87500 Door Handle service bulletin

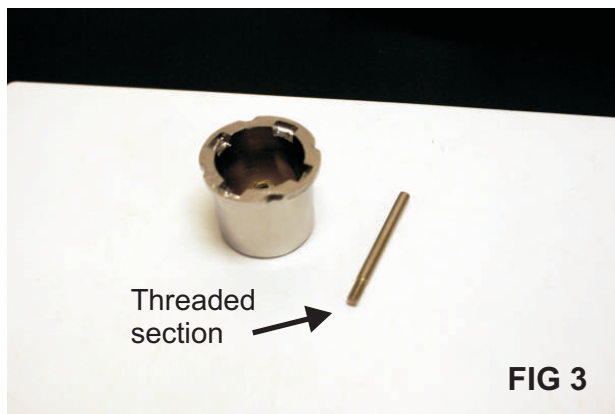
We have identified a potential issue with the JK door handles that is easily remedied but is not at first obvious. If the button shaft is not tightened properly it can interfere with the lock mechanism. If not tight it can also unscrew and fall out making the door handle not operate.

Remove the keeper bracket with a Phillips screw driver. (FIG 1) Note the difference in the length of the two shafts (FIG 2). The part on the left is not screwed into the button far enough and could keep the lock mechanism from operating properly. You can see in the picture below (FIG 3) that the shaft is threaded on the end. In some cases it may not be installed into the button properly.

Use a pair of pliers to tighten the shaft into the button. Grip the shaft as far into the button as possible so as not to damage it in the area that slides through the keeper bracket.

It is a good idea to grease the shaft in the area shown below before re-assembly.
